SERVICE LETTER SL33 66-12200

1. **Release Date:** 08/08/2017
2. **Service Letter No.:** SL33 66-12200
3. **Reason for Change:** Alternate installation of water rudder retract handle allows for additional throw and adjustability to water rudder retract handle with use of a pulley and different anchor point for the retract cable.
4. **Part/Assembly No.:** 66-12200, 66-12201, 66-12202
5. **Float Model Affected:** 6650
6. **Disposition of Product in Field:** Optional
7. **Approval:** All information provided is in accordance with approved data.
8. **Corrective Action:** NA
9. **Time Required:** 1 Hour
10. **Payments to Customer:** None. Call (208) 448-0400 for Parts Department

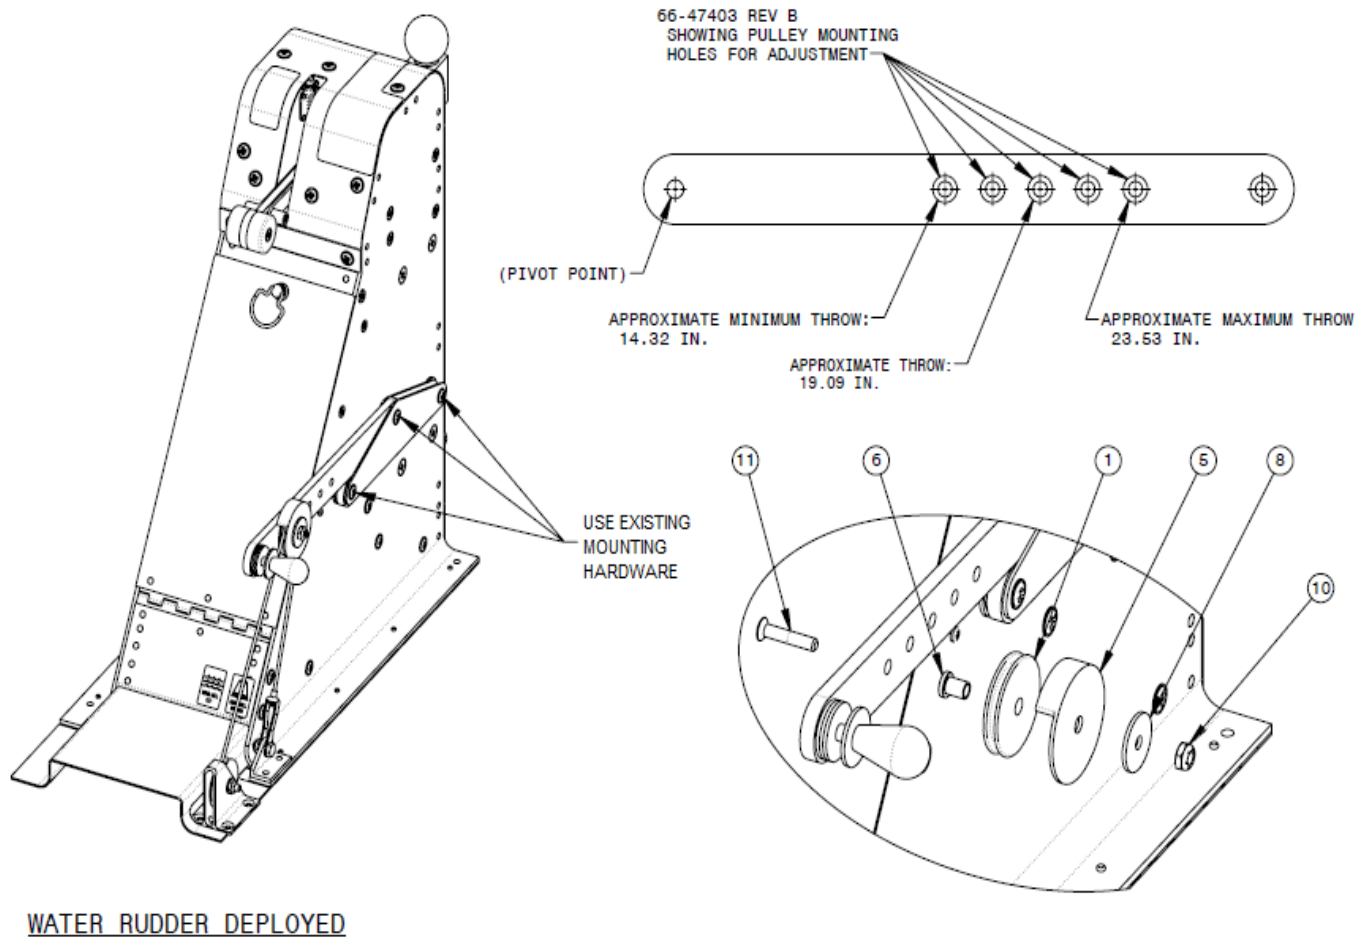
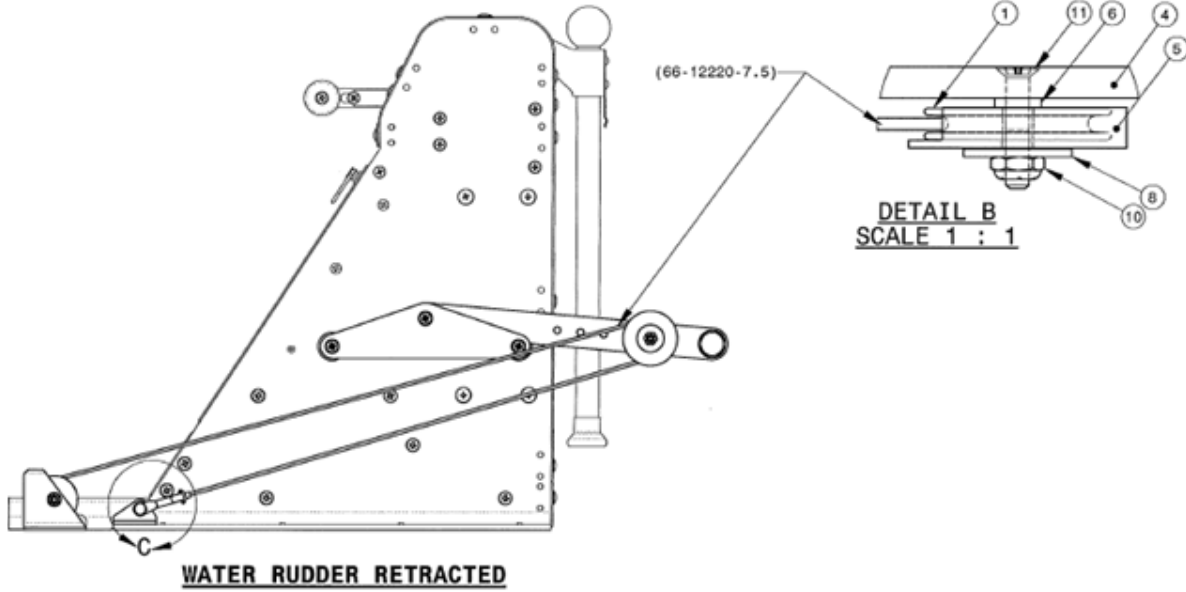
1. Water rudder retract handle, (alternate installation (shown) is intended to provide installers and operators a means of additional adjustment to water rudders

3. By use of the pulley and anchor system shown, the throw of the of the retract handle is increased, which will result in a water rudder that is higher when in the retracted position than it would be without.

- a. Larger adjustments must first be done in the context of the 66-12200 rigging installation drawing.
 - b. Finer, incremental adjustments can be accomplished by the choice of fastener hole in 66-47403 arm.

- c. NOTE: Holes that are the farthest from the retract arm pivot will have the most throw, while holes that are closest will have the least throw.
4. Water rudder shall reach full extended (deployed condition when arm is in the full, forward position, in accordance with drawing number 66-12200.

5. Assure free travel of retract handle, pulley and cable.
